Access Compliance Report Public Rights-of-Way (Pedestrian Signals)

Main Street: **N_MEADS_AVE** Cross Street: **WILDERNESS_AVE** Location: **SE**

ADA ID: **SGRK211222123853** Signal Type: **One Push Button-Non APS** Overall Compliance: **No** Severity Scores: **BTN 1: 35** **BTN 2: N/A** **No BTN: N/A**

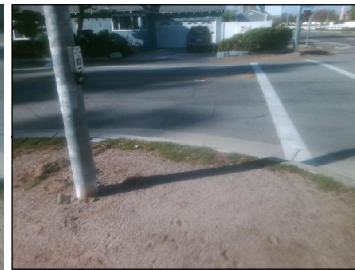
OC Std/PROW: MUTCD 4e.08, R404.3, R404.1, DMS-11132, R104.2, R209.1

Possible Solutions: Replace Signal Push Button With APS Button. Remove & Relocate Sign.
